CITY OF AUSTIN
Board of Adjustment/Sign Review Board
Decision Sheet (INTERPRETATION)

CASE NUMBER: C15-2015-0038

VARIANCE REQUESTED: The appellant has filed an application challenging the Planning and Review Department's staff memo stating Subchapter F, Article 3, Section 3.3.3 (C) "serves no purpose and is not interpretable".

Board of Adjustment Motion Sheet

Figure 14: 18-foot Exception for Shed Roof

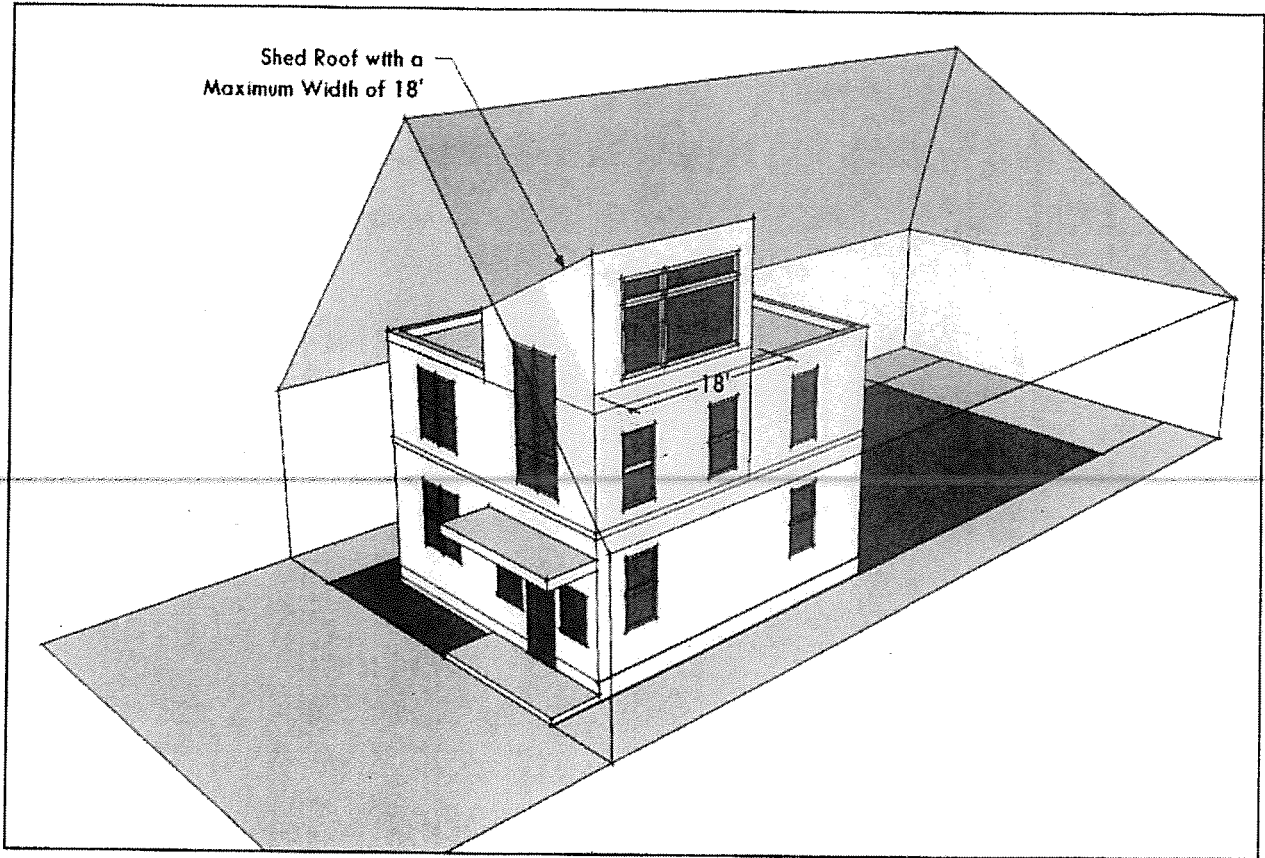
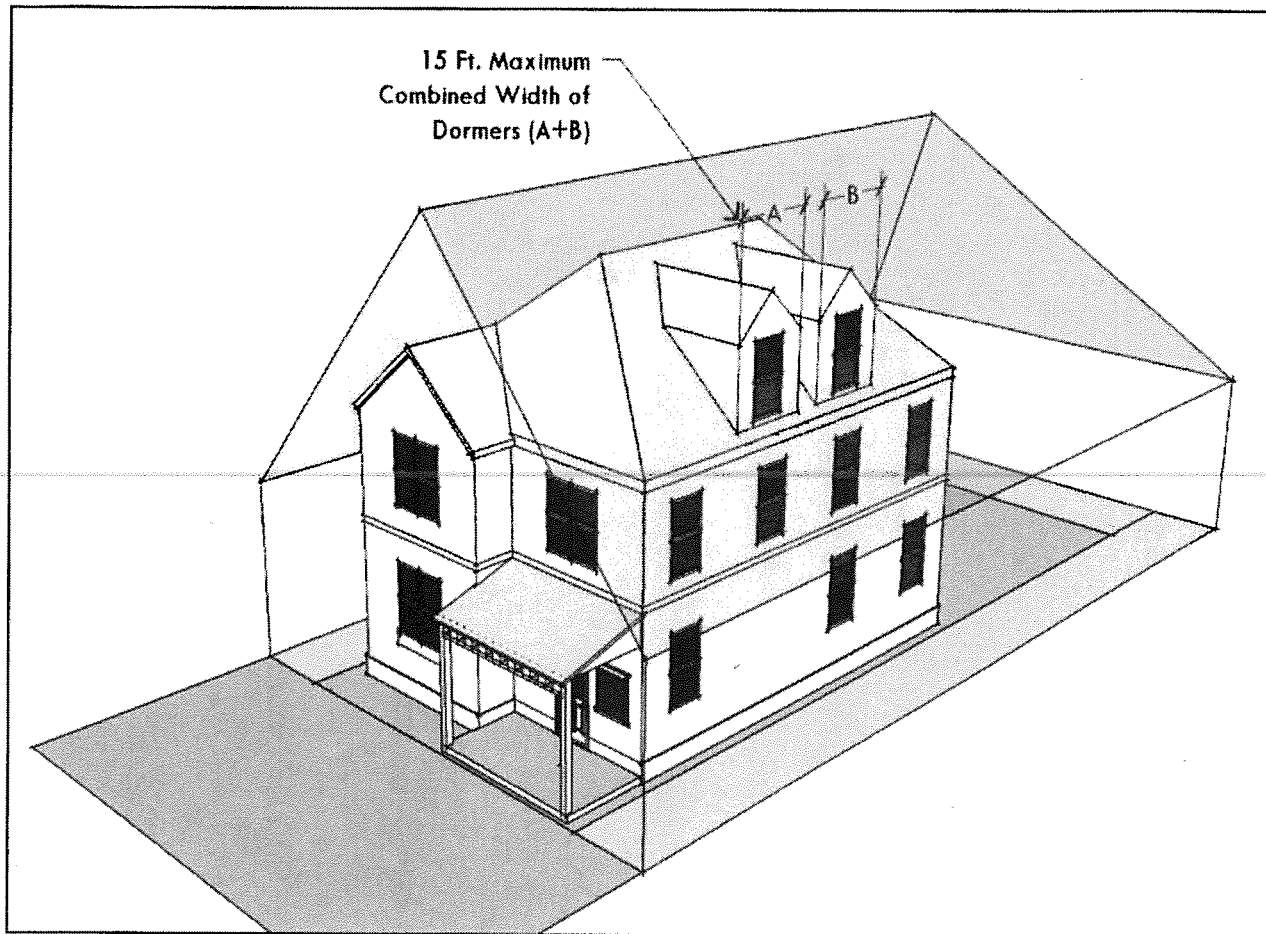
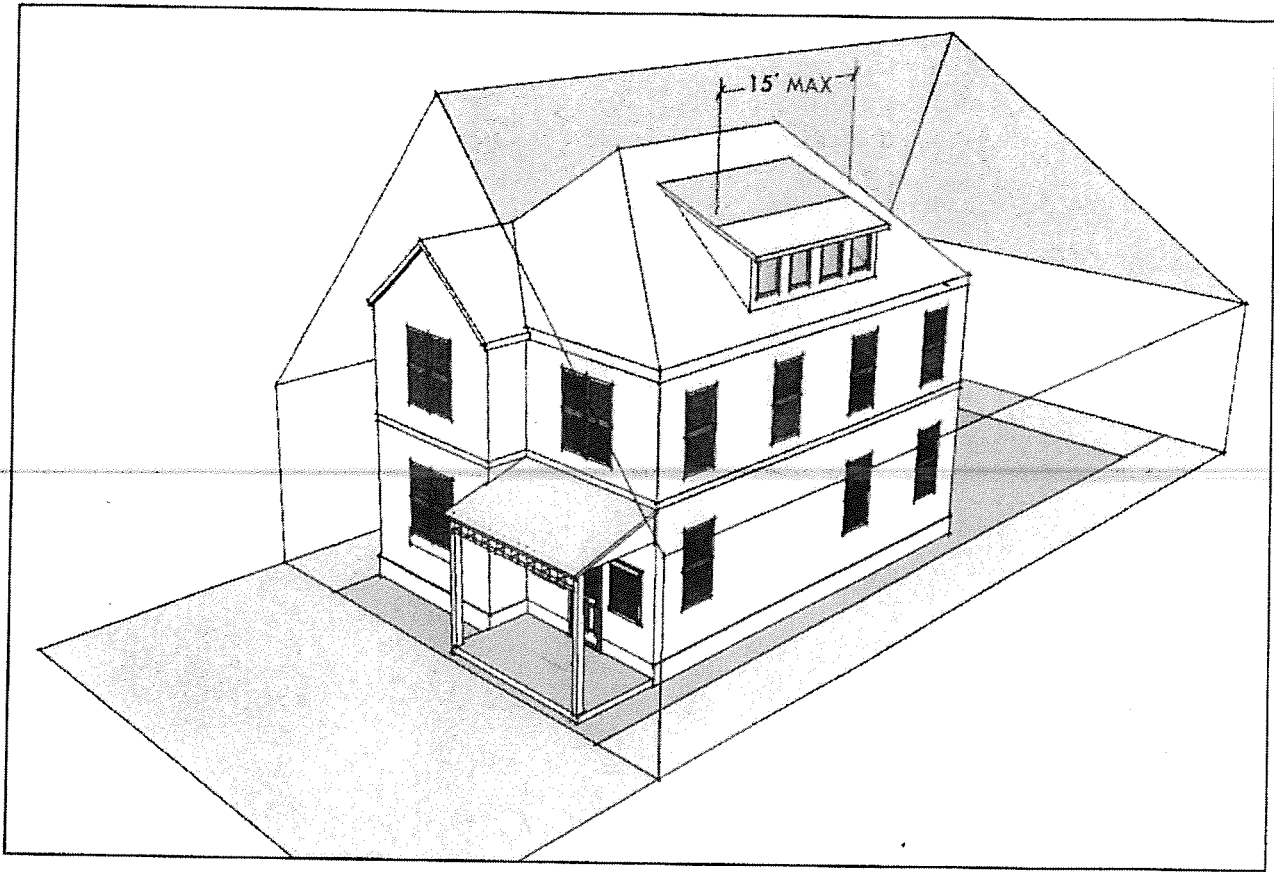
The ordinance recognizes that dormers of several types are an architectural feature common to many attic spaces. These dormers are allowed by the code to penetrate the "Tent" as illustrated in the attached figures 14, 15 and 16 from the code. So the question becomes, that while allowed by the code do they add additional mass to the building beyond what was intended by the code? If they do then they would not meet the requirement that they add no more additional mass to the building so that they would not qualify for the exemption.

McMAUSICH "TENT" DEFINED
1/8" = 1'-0"

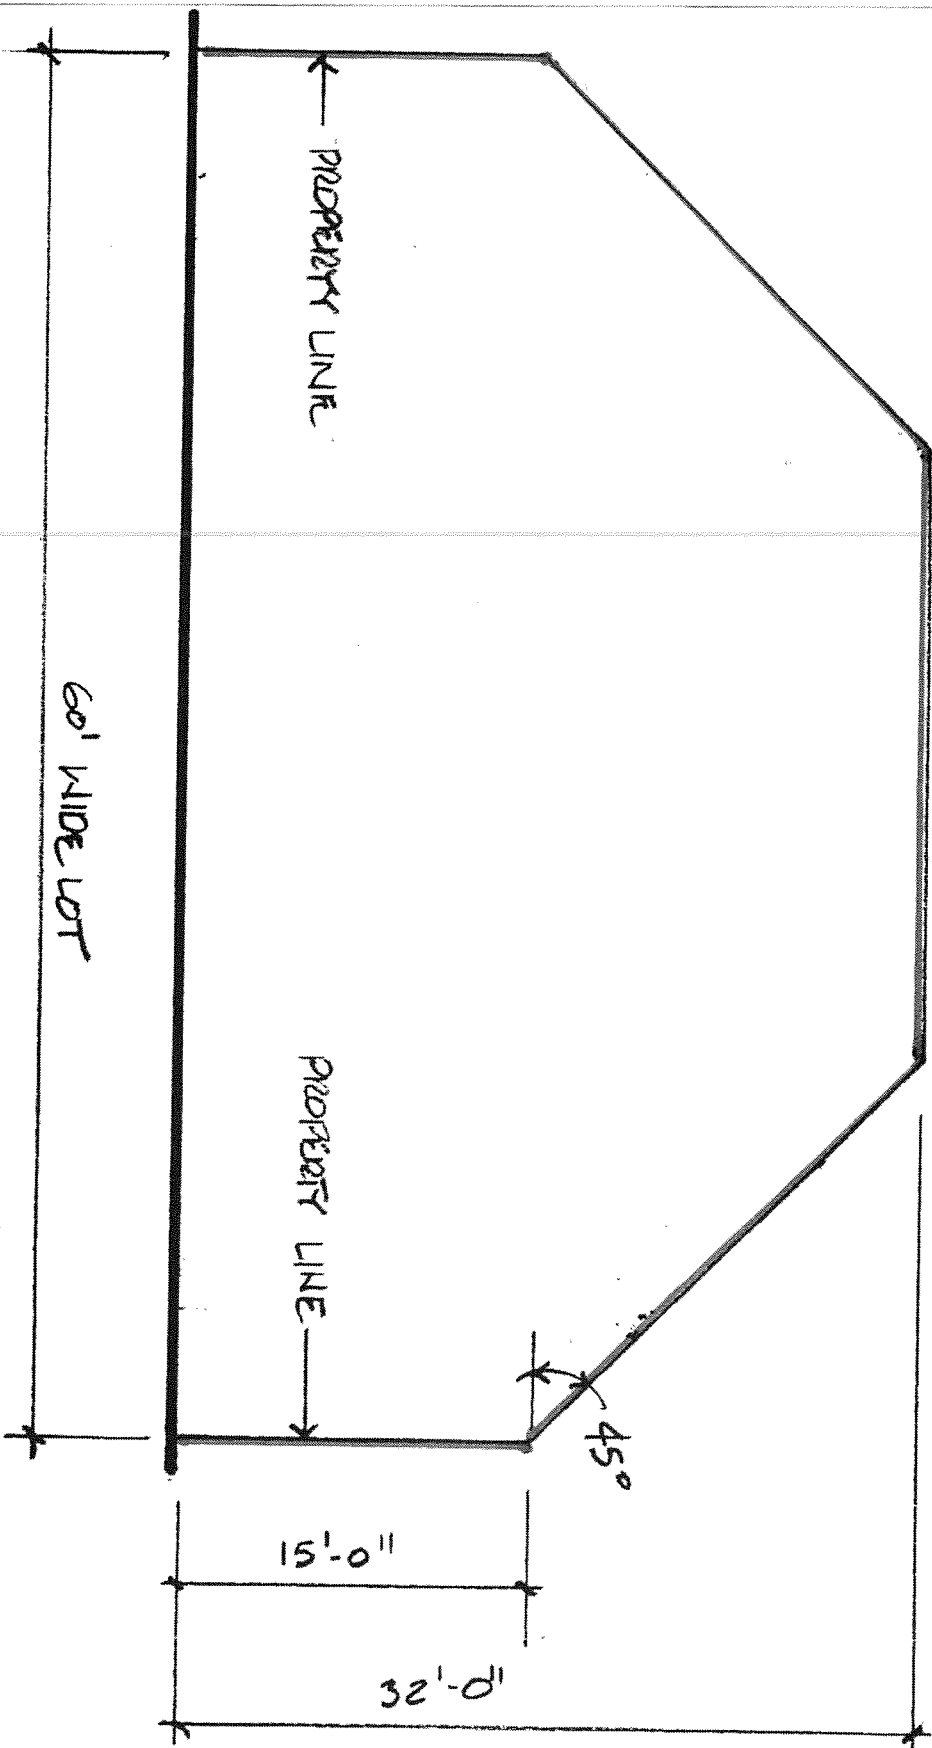
The underlying question is if a building utilizes the maximum extent of the "Tent" as defined by the parameters noted above is it still in conformance with the code? See illustration T-1. The code itself is silent on this issue so it seems reasonable to assert that one could design a building that extended to the limits of the "Tent" and it would be in compliance so long as it met the FAR restriction. See illustration T-2. While such a design is probably not feasible due to other code provisions, such as not having a flat roof, a typical design such as illustrated in T-3 is certainly compliant with these parameters of the code.

HOUSE WITH NON-COMPLAINT DORMERS FOR FAR EXEMPTION
 1/3" = 1'-0"

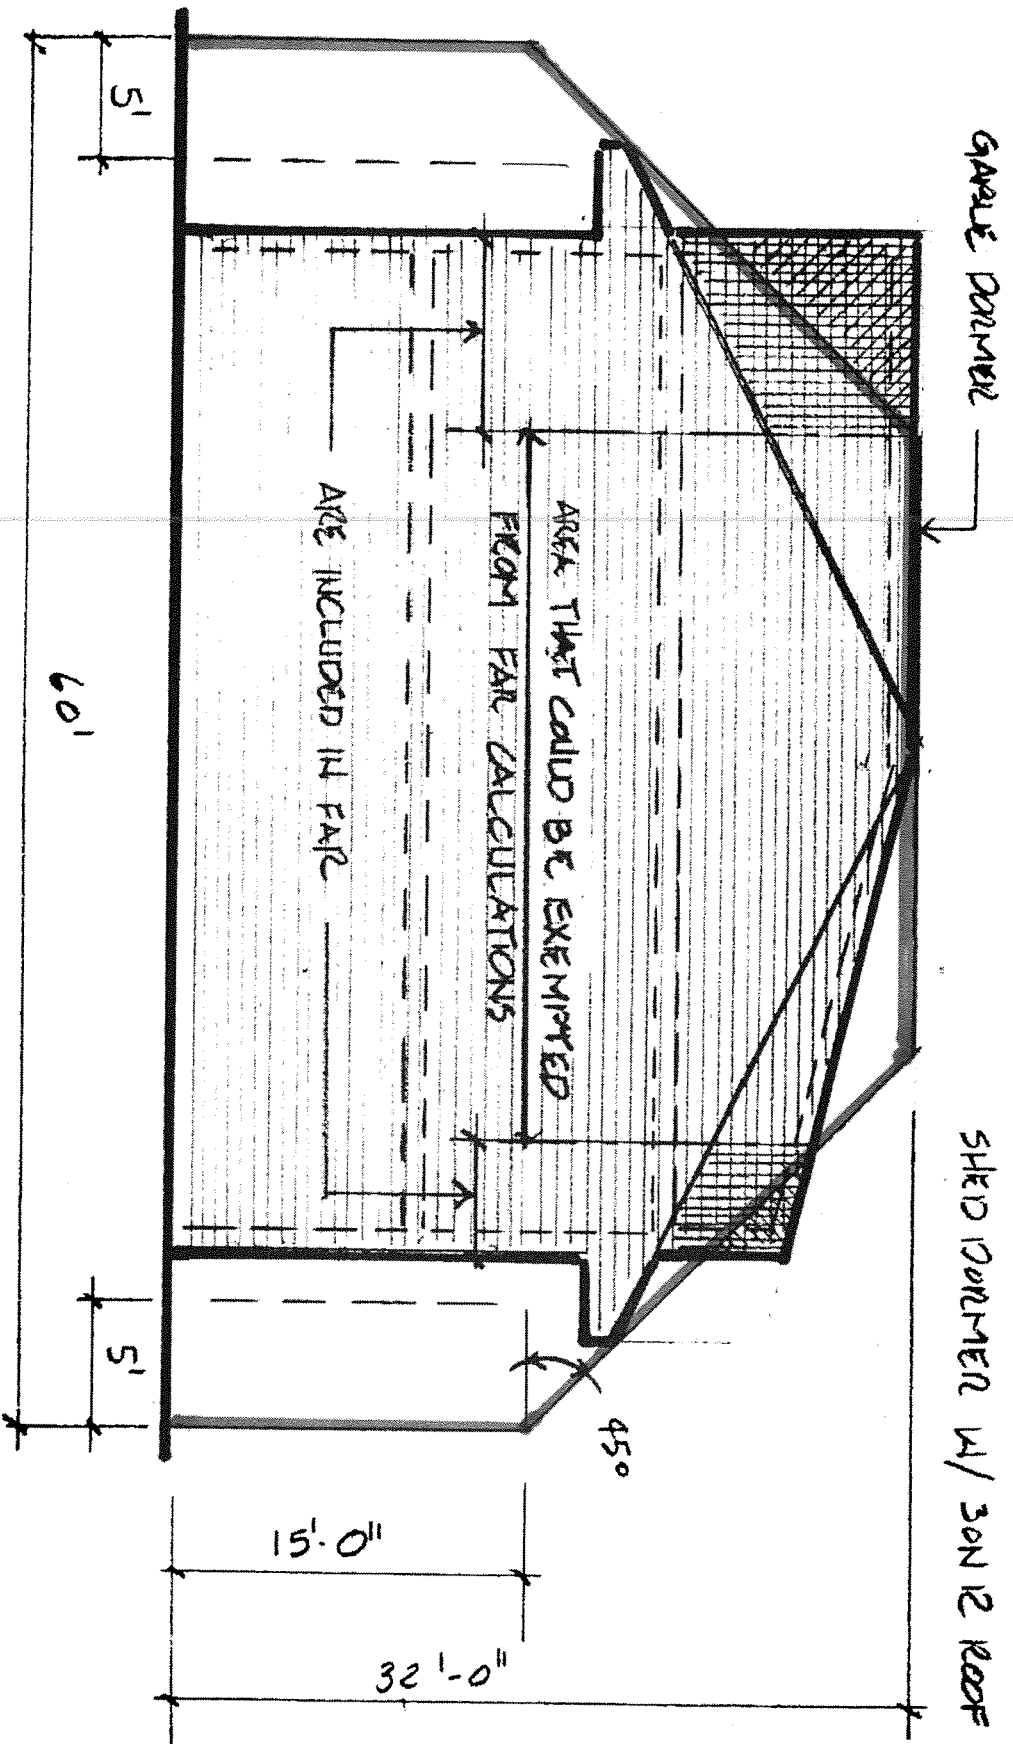
Therefore if any design is proposed within the limitation of massing defined by the "Tent" and FAR acceptable? If the "tent" was intended to be the maximum limit to massing, given a building meeting all other requirements such as FAR, Building Coverage and Impervious Coverage I believe the correct interpretation is that any dormer that can be contained within the acceptable limits of massing defined by the "Tent" is not adding to the massing allowed by the "Tent". While such dormer will indeed add massing to a similar structure that does not have dormers, it is not adding massing above what the "tent" would allow so long as it also meets the FAR limitation. In which case any additional floor area of a dormer contained within the "Tent" that meets the other requirements for an attic exemption would be excluded from the calculation of FAR. Please see attached illustration "T-4".

GABLE DORMER W/ EXTERIOR
WALL @ EXTERIOR PERIMETER
WALL ELEVATION

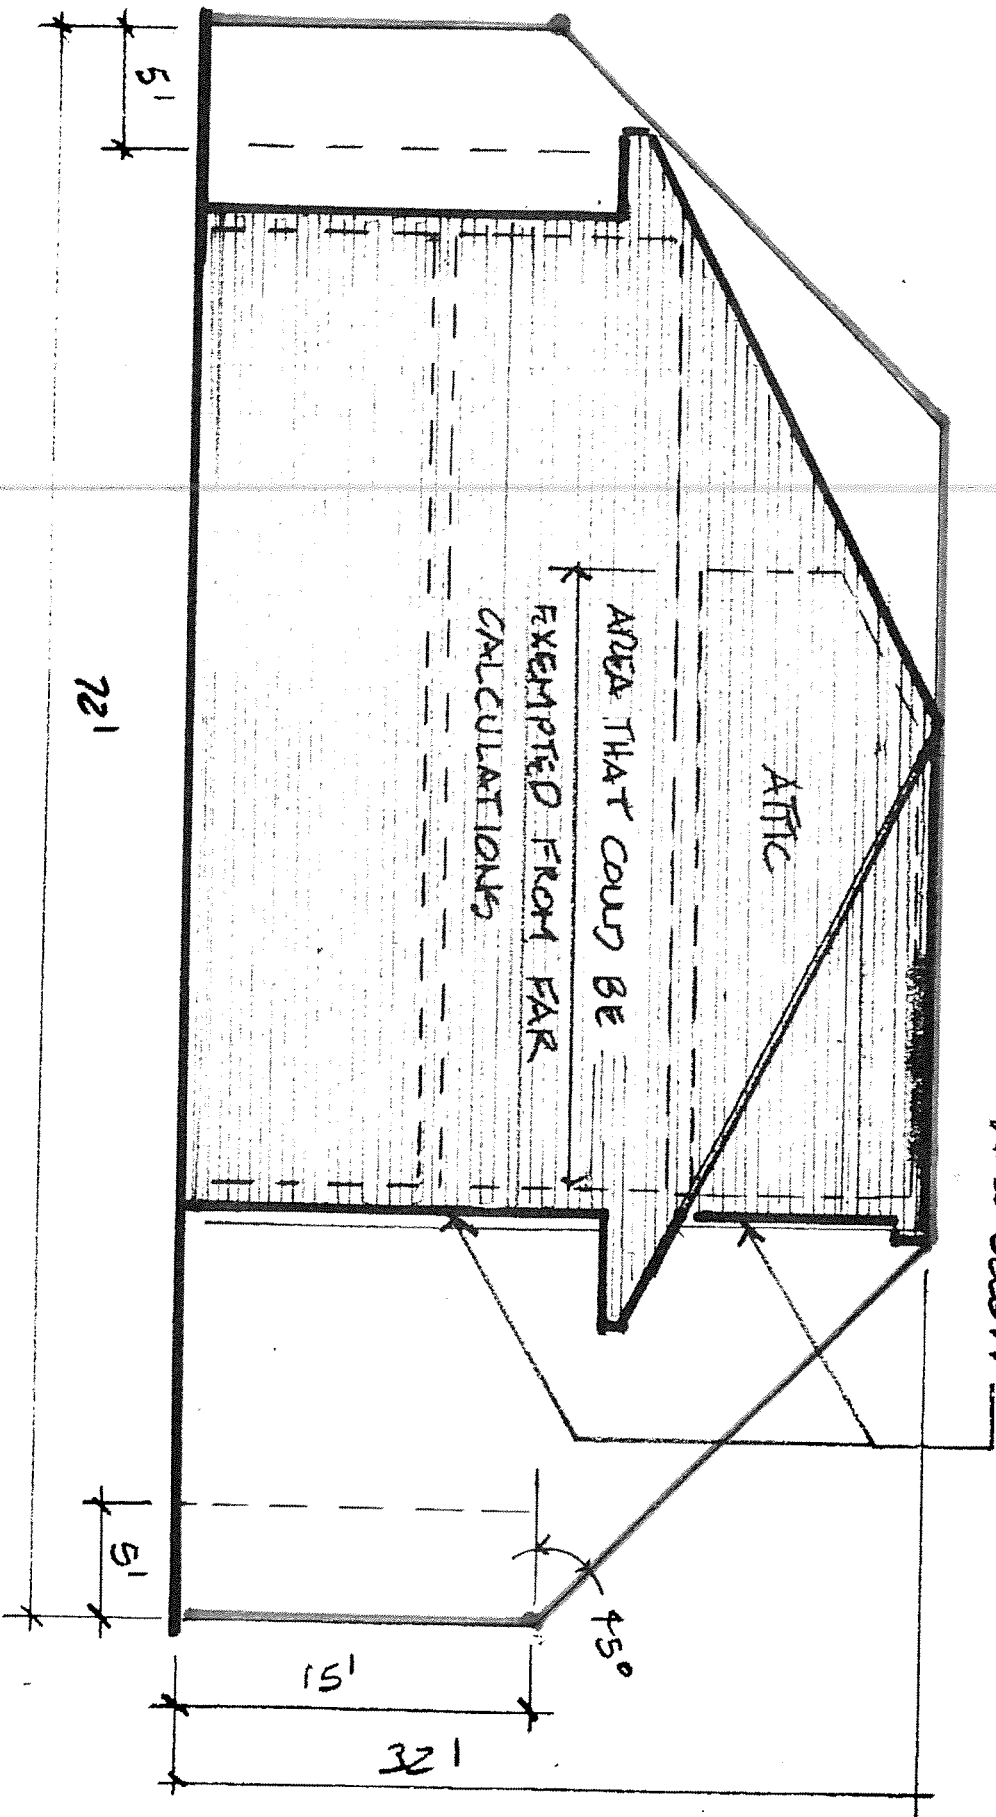
As for dormers with configurations similar to figure #4 in Daniel Words memo concerning whether or not they are “fully contained within the roof structure”, once again we have to defer to the McMansion ordinance use of the tent and FAR to describe the acceptable massing allowed. And that allowable massing is a variable due to the lot size and configuration. As illustration T-6 indicates a larger lot with a comparable larger “Tent” could have a dormer with an exterior wall/roof relationship like figure #4 of the Daniel Word memo, but still be within the limits of the “Tent” applicable to that property and so long as it met the FAR requirement.
